Project No. 112G00352

RE: **Final**
Response to United States Environmental Protection Agency (EPA) E-Mail Comments
Dated April 10, 2008 on Interim Measures Work Plan (IMWP) for Solid Waste
Management Unit (SWMU) 13 (Mine Fill B)
Naval Surface Warfare Center (NSWC) Crane
Crane, Indiana

**RESPONSE TO COMMENTS (RTCs) DATED APRIL 10, 2008
FROM UNITED STATES ENVIRONMENTAL PROTECTION AGENCY (EPA)
(E-MAIL FROM PETER RAMANAUSKAS)
ON THE INTERIM MEASURES WORK PLAN (IMWP) RTCs DATED DECEMBER 20, 2007
FOR SWMU 13 – MINE FILL B
NAVAL SURFACE WARFARE CENTER
CRANE, INDIANA**

FIGURES 3-1, 3-2, AND 3-3

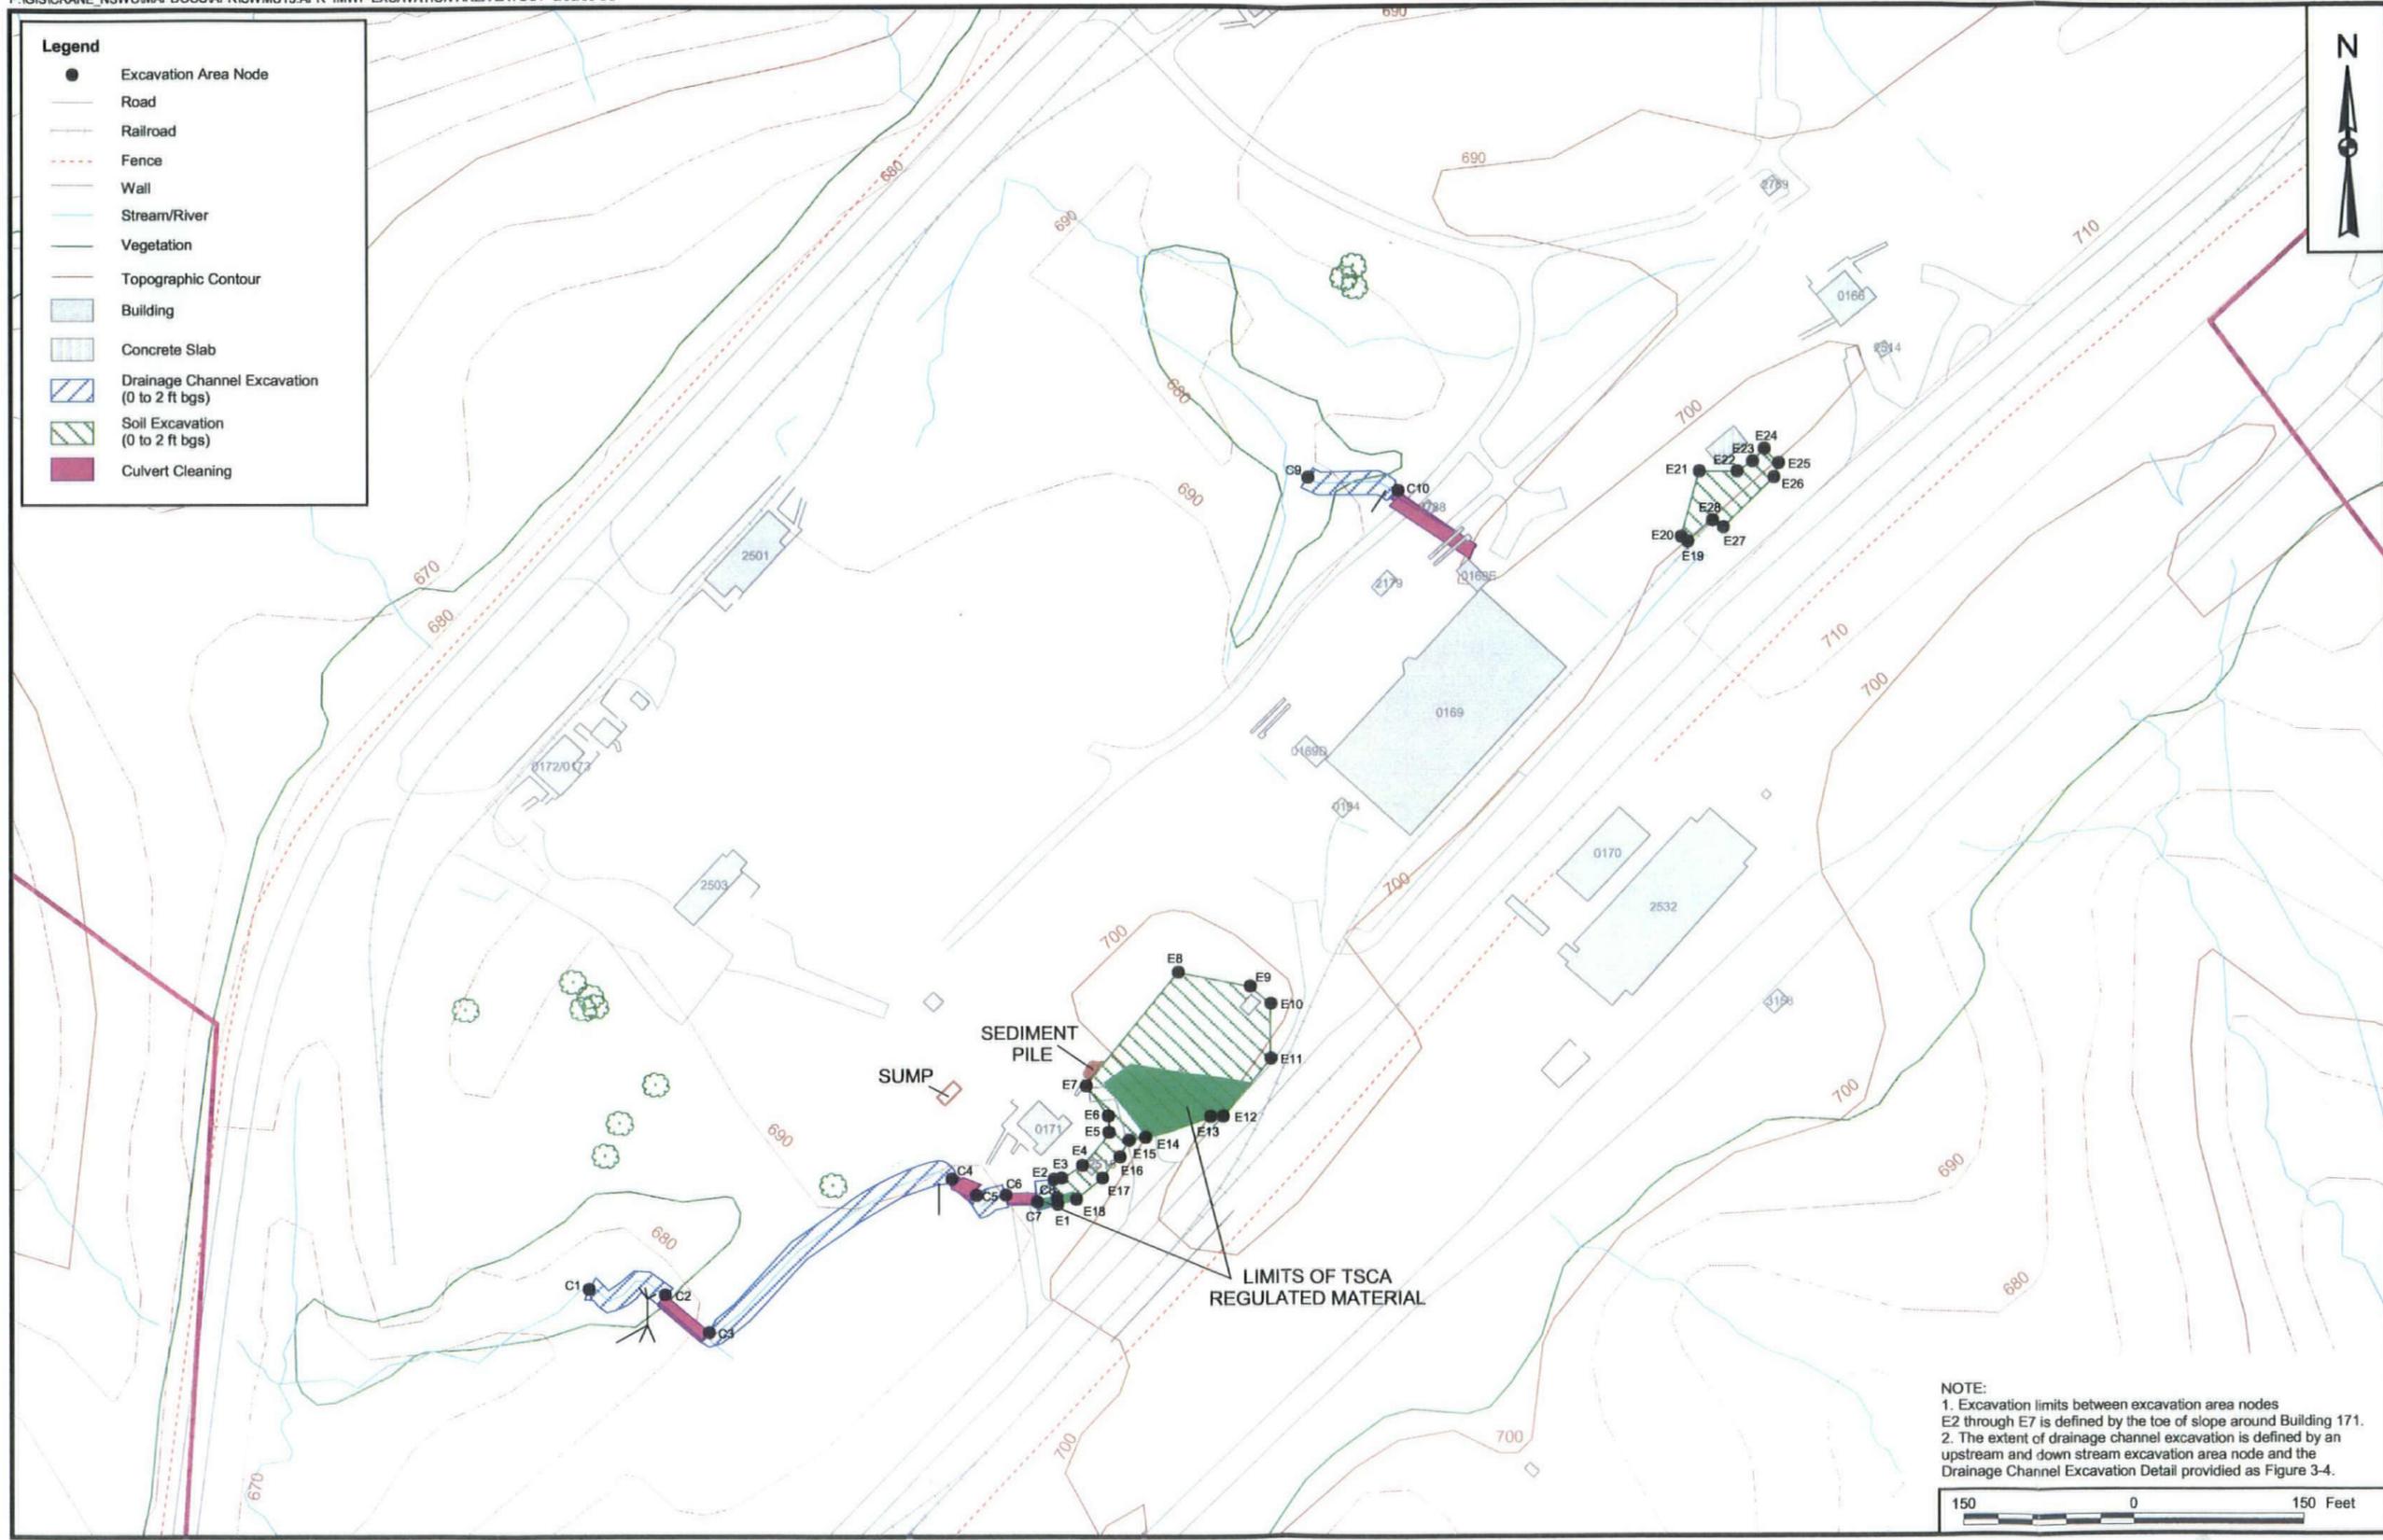
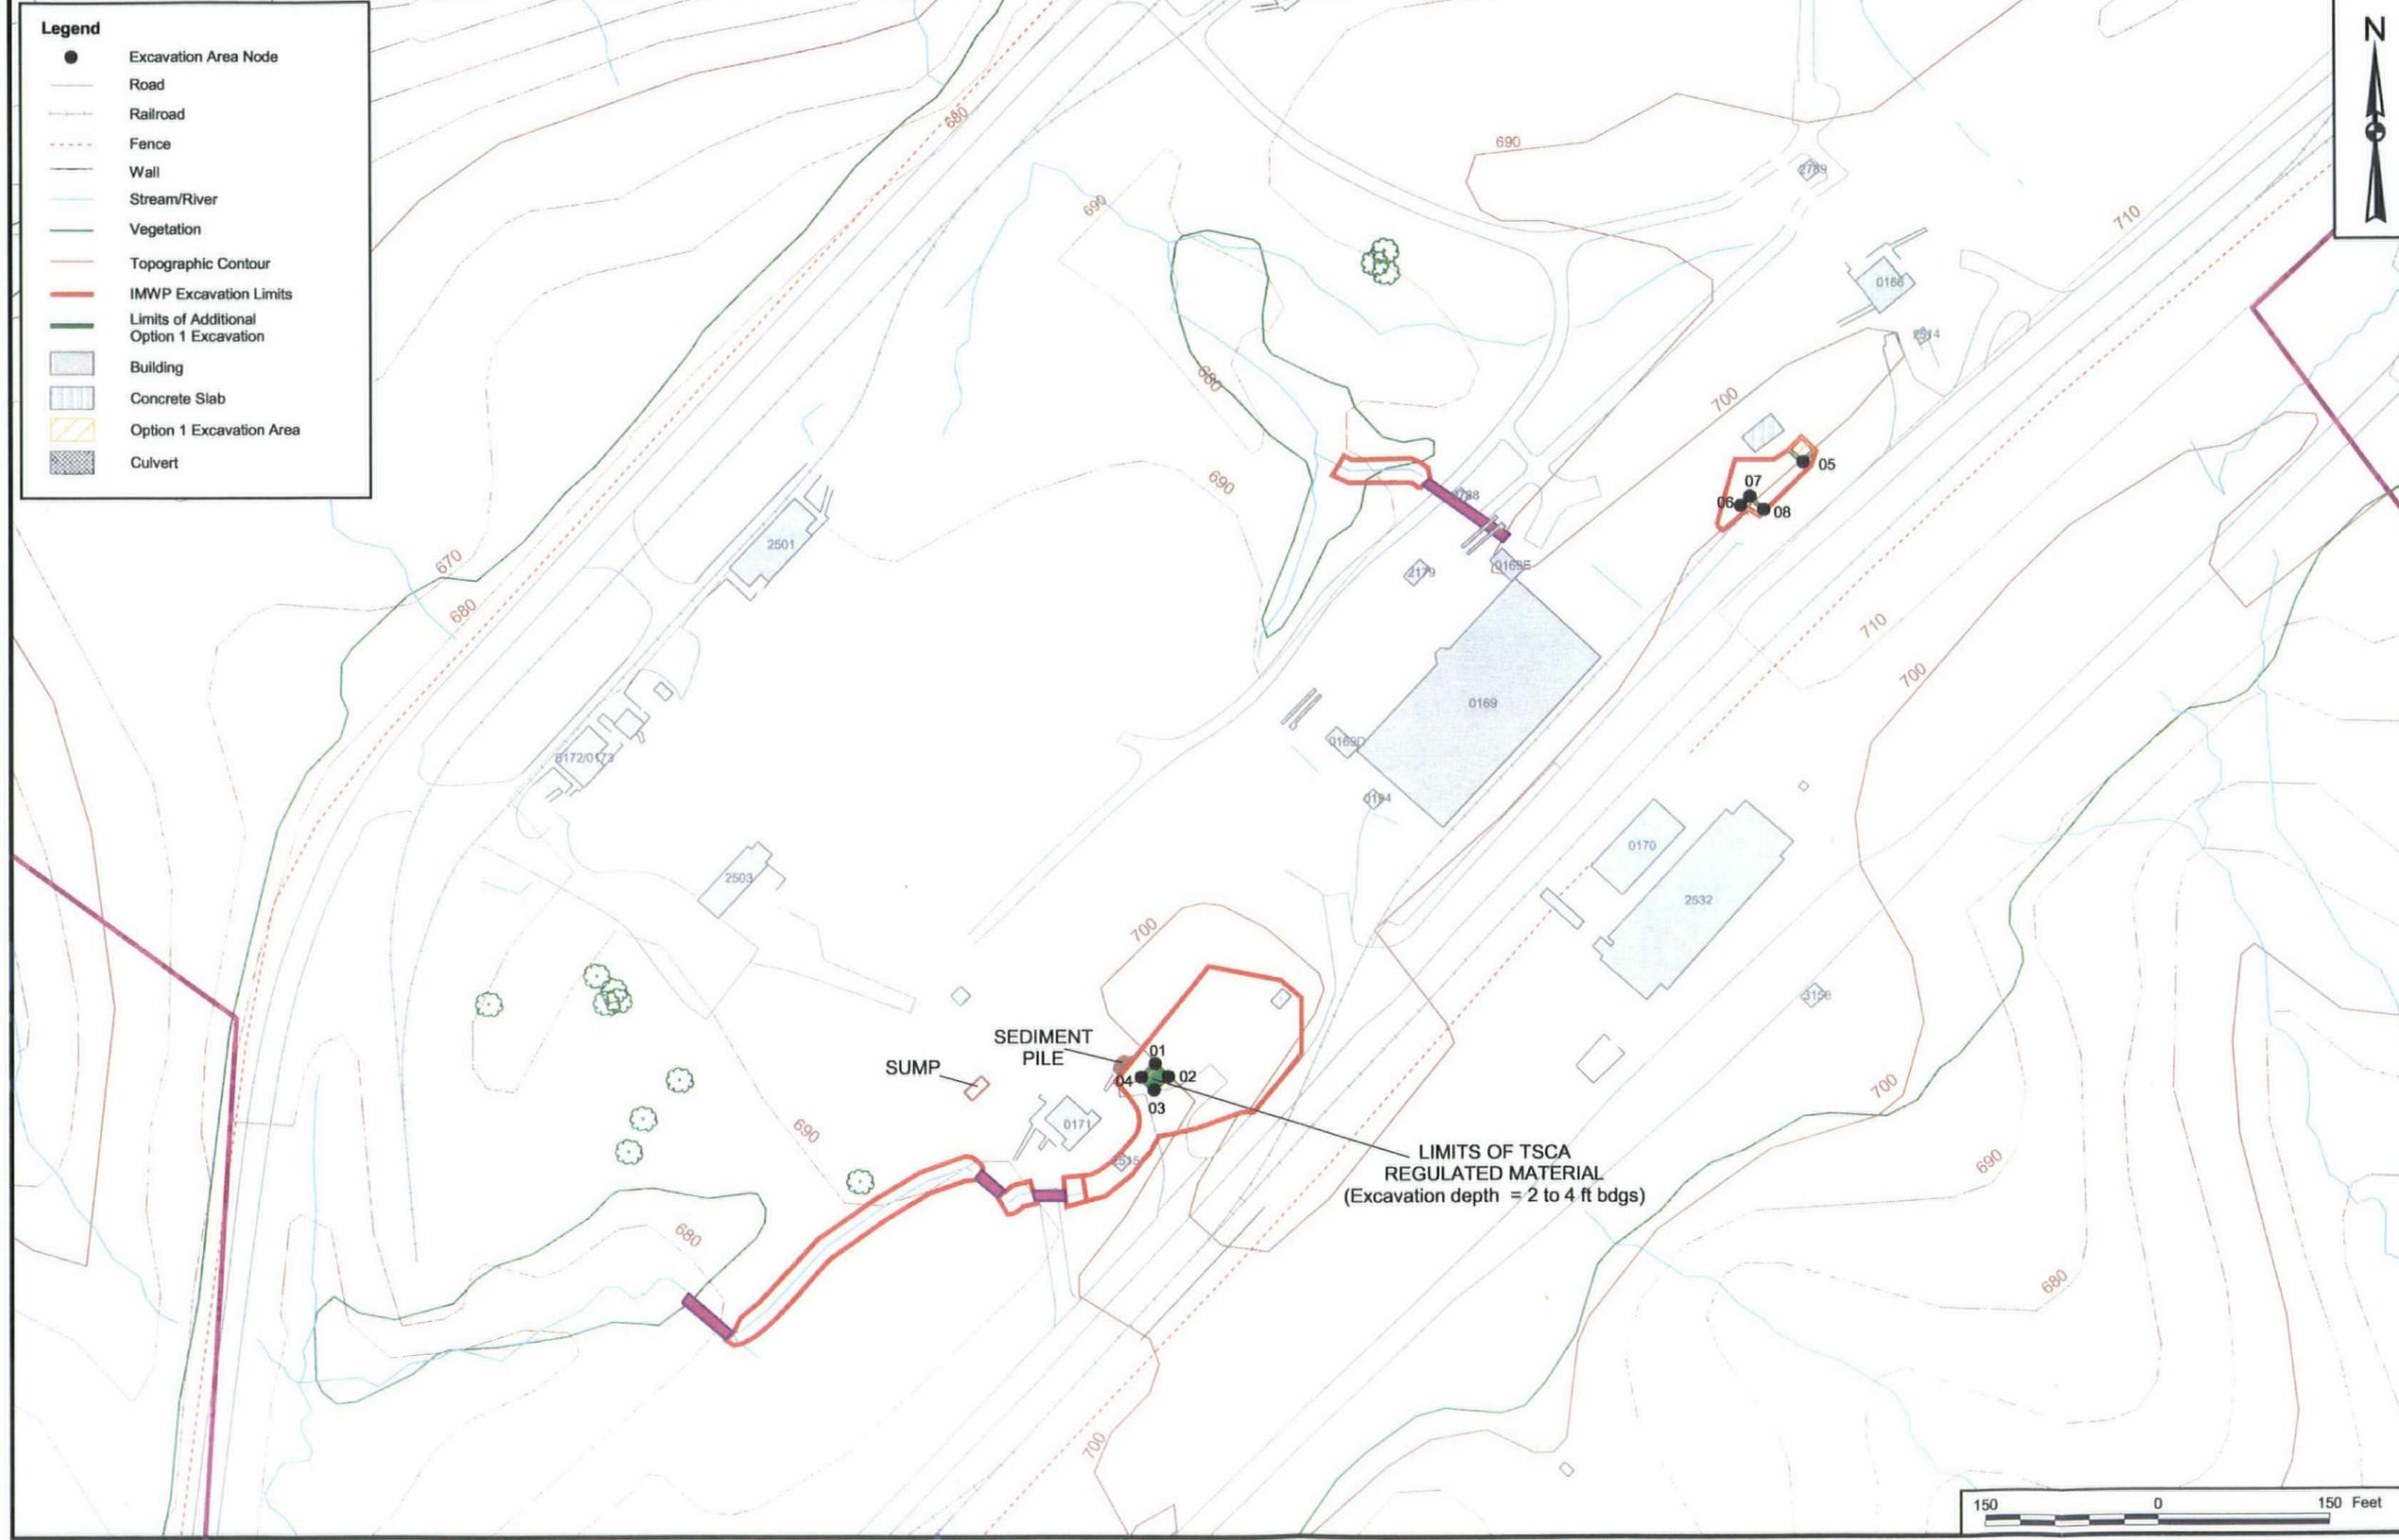
Response 1c does not address the comment. Overall, the text remains confusing with respect to which buildings were known to have PCB use and which buildings are having PCB contaminated soil removed. For example, Section 3 describes work around B-169 and B-171 but does not talk about B-166 while Figure 3-1 shows work proposed around B-166. Some places in the text discuss B-166/171 and others B-169/171. Please describe work taking place at all three buildings and what the sources of PCB were at each building. If a building did not have a source of PCB, describe how PCB came to be located near the building.

Response to EPA-1 (4-10-08): Figures 3-1, 3-2, and 3-3 indicate a fenced area northeast of Building 169 with "0166." This area is a fenced in area where the former Building 166 Therminol Boilers were located. The Therminol Boilers for Building 166 and Building 171 are believed to be the sources of polychlorinated biphenyl (PCB) contamination at SWMU 13 (Mind Fill B). PCB activities did not occur at Building 169. The purpose of referencing Building 169 is as a landmark for the remediation Environmental Multi Award Contractor (EMAC). The Navy believes that it is appropriate to use Building 169 as a landmark because of its location relative to the proposed remediation areas.

For clarification, Figure 3-1, 3-2, and 3-3 (See Attachment 1) have been modified to include a legend for the former foundation pad of the Therminol Boilers rather than fenced areas. Additionally, these figures have been modified to show Building 166.

EPA-5c (4-10-08): Sediments must be tested for PCB concentration for disposal characterization prior to any consolidation. > 50 ppm and < 50 ppm materials should be kept segregated.

Based on the available analytical data, 6 sample locations contain total-PCBs at concentrations that exceed 50 mg/kg. Figures 3-1, 3-2, and 3-3 have been revised to indicate the locations of the soils that must be stockpiled separately for disposal at a TSCA regulated landfill. Additionally, the text and volume tables have been updated to indicate the inclusion of material to be disposed at a TSCA regulated landfill. Additional sampling for disposal will be performed based upon requirements of the selected landfill.
